# Pa Road - Kerikeri Footpath

Road Safety Audit  
Design Stage  
October 2020

**Figure 3: Possible improvements at the intersection .**

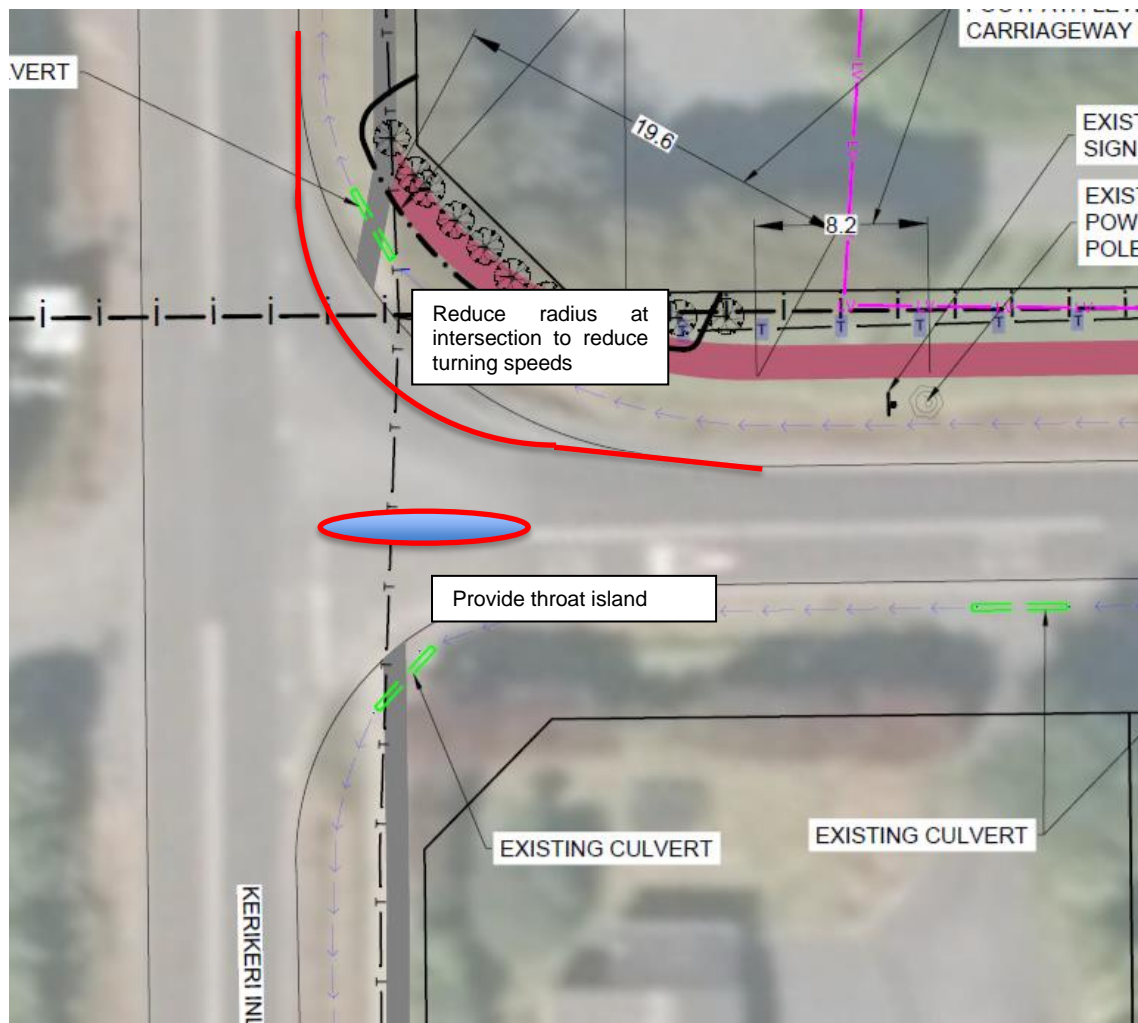
1. Relocate the footpath to the east side of Pa Road.

2. Reduce the radius turning into Pa Road.

Designer Response: Accepted

Safety Engineer: Agree with both auditors and designer. This is outside scope, but should either be included or created as a follow up project for future annual plan.

**Client Decision: Agree with the designer**

Action Taken: Design revised and footpath to be relocated to the eastern side.

Designer Response: Not accepted – intersection improvements not part of scope

Safety Engineer: Agree with both auditors and designer. This is outside scope but should either be included or created as a follow up project for future annual plan.

**Client Decision: Agree with designer and safety engineer.**

Action Taken: Intersection improvement will be recommended to the safety/Asset management team for inclusion in the annual/LTP as a separate project.

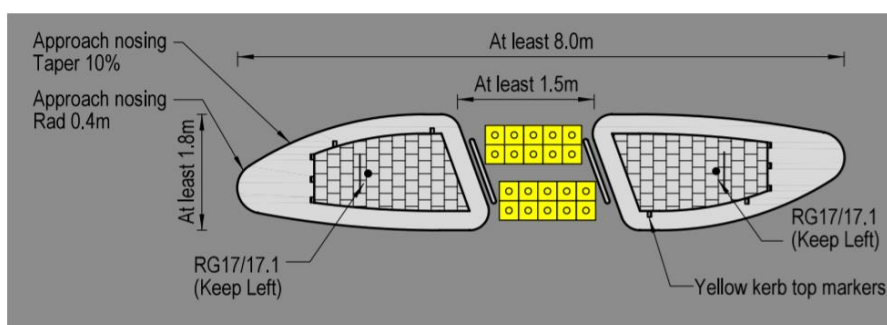
3. Provide a Pedestrian Island 'throat island' at the intersection of Pa Road and Kerikeri Inlet Road of a type shown below.

Designer Response: Not accepted – intersection improvements not part of scope

Safety Engineer: Agree with both auditors and designer. This is outside scope, but should either be included or created as a follow up project for future annual plan.

**Client Decision: Agree with both the designer and safety engineer**

Action Taken: No action required at this stage but recommendation will be given to the safety/Asset management team to consider intersection improvement as a separate project in the annual plan/LTP.

**Figure 8 : Curve Ch 650- 700.**

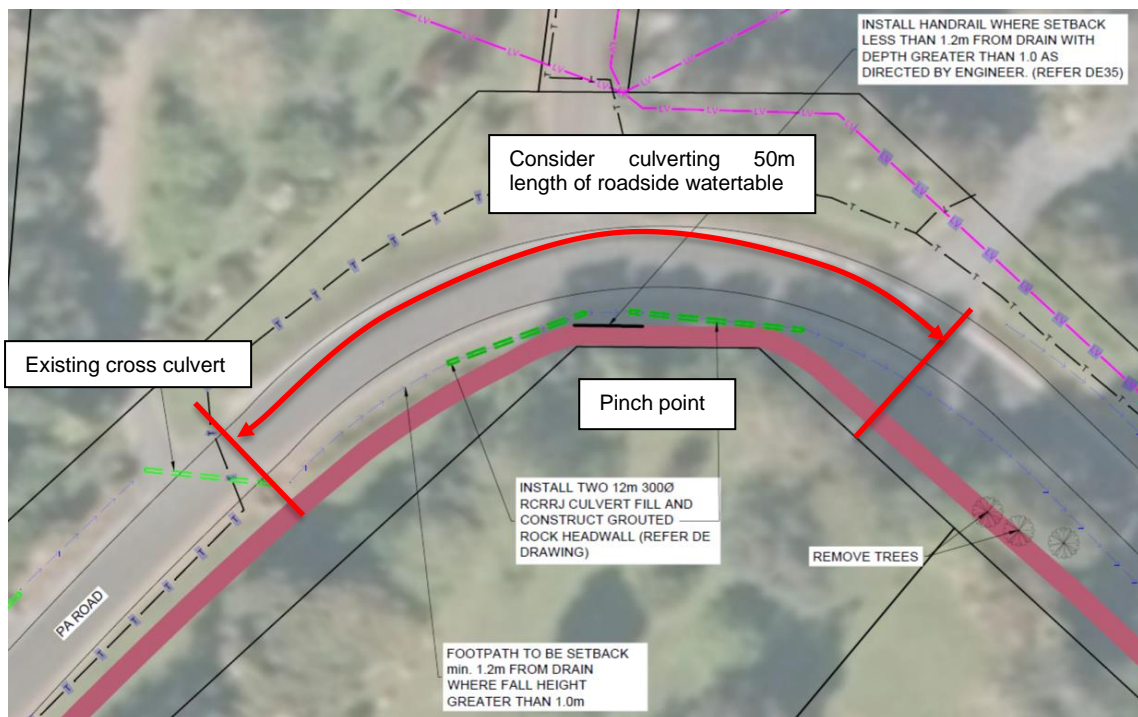
In order to gain space to fit the footpath past the pinch point caused by the boundary corner it is proposed to culvert two 10m section of the roadside water table and provide a handrail on the footpath at the pinch point. This leaves approximately 20m of water table between this culverting and the cross culvert under Pa Road. The short remaining lengths of open drain and the handrail are roadside hazards that could be eliminated by culverting the roadside water table for about 50m from the cross culvert. **Figure 7** shows the existing situation and **Figure 8** shows the features described above.

Consider pipe culverting approximately 50m of roadside water table to remove short lengths of steep open roadside drain and remove the necessity for a handrail.

**Designer Response:** Not accepted – the proposed culvert arrangement avoids the need for manholes at change in direction and provides the most cost-effective solution. The road is un-kerbed and open roadside drainage is a common feature. The open drain hazard is an existing feature which is not exacerbated by the proposed footpath. It could be argued that the open drain provides protection to pedestrians from an errant vehicle. Further infilling of the drain would reduce this protection. The depth of the drain is not considered sufficiently deep to present more than a minor hazard, an errant vehicle would not come to a dead stop and is unlikely to roll. The depth of the ditch could be moderated by placing anti scour rock armour in the invert but even this is not considered necessary.

**Safety Engineer:** Agree with Designer, the cost/benefit would not add up. If any money was spent on improving the safety level of service, it would be better spent on purchasing two small triangles of lane at the boundary corners to enable further separation between path and drain. Although I don't believe this is warranted either.

**Client Decision:** Agree with both the designer and safety engineer.

Action Taken: Revised drawings will show the over-deep section of water table lined with rockspall to mitigate further scouring

**Figure 10 : Extract of design drawings showing section of existing water table to be culverted and section to remain**

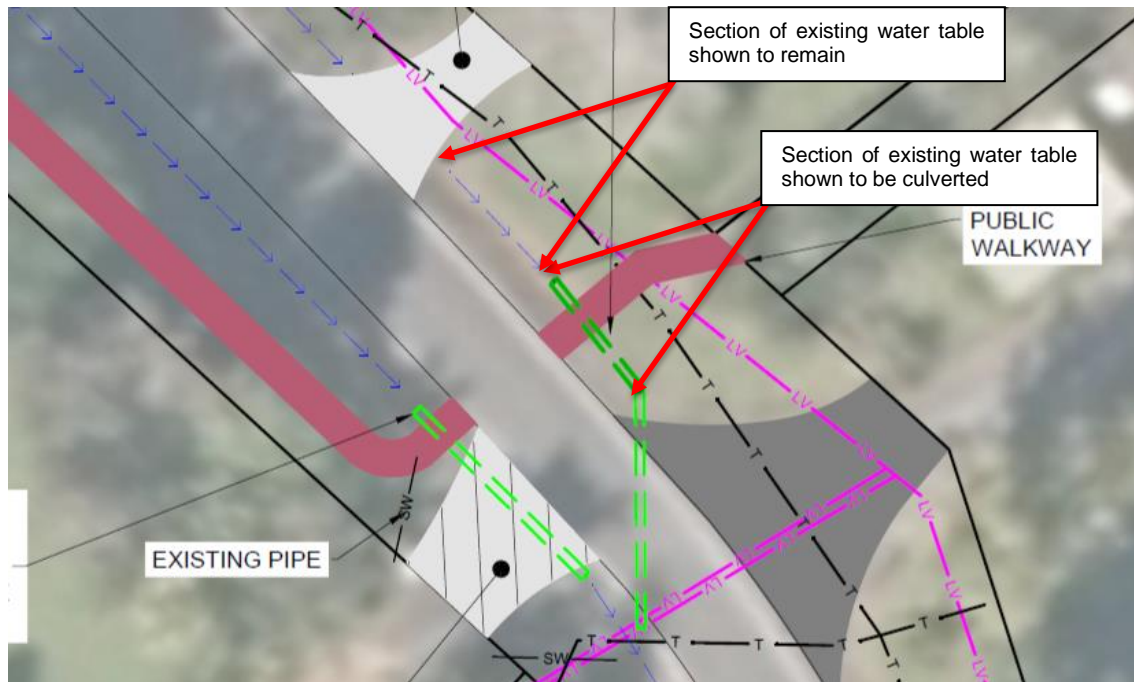
In order to construct the crossing point to link the proposed footpath to the existing footpath approximately 6m of the existing roadside water table is shown to be culverted. This leaves approximately 6m remaining between this culverted section and the nearby driveway culvert. This short length presents a roadside hazard, particularly as it is on the outside of the curve. It is possible that a vehicle could crash into this short length of culvert either by losing control or by not realising its presence.

**Figure 9** shows this short length of open water table and **Figure 10** shows the proposed design showing water table to be culverted and that to remain open.

Consider extending the culverting of the water table to the adjacent driveway.

Designer Response: Not accepted – The road is un-kerbed and open roadside drainage is a common feature. The open drain hazard is an existing feature which is not exacerbated by the proposed footpath. The depth of the drain is not considered sufficiently deep to present more than a moderate hazard, an errant vehicle would not come to a dead stop and is unlikely to roll. The depth of the ditch could be moderated by placing anti scour rock armour in the invert but even this is not considered necessary.

Safety Engineer: Agree with designer, outside the remit and scope of this project.

**Client Decision: Agree with both the designer and safety engineer.**

Action Taken: No action needed.
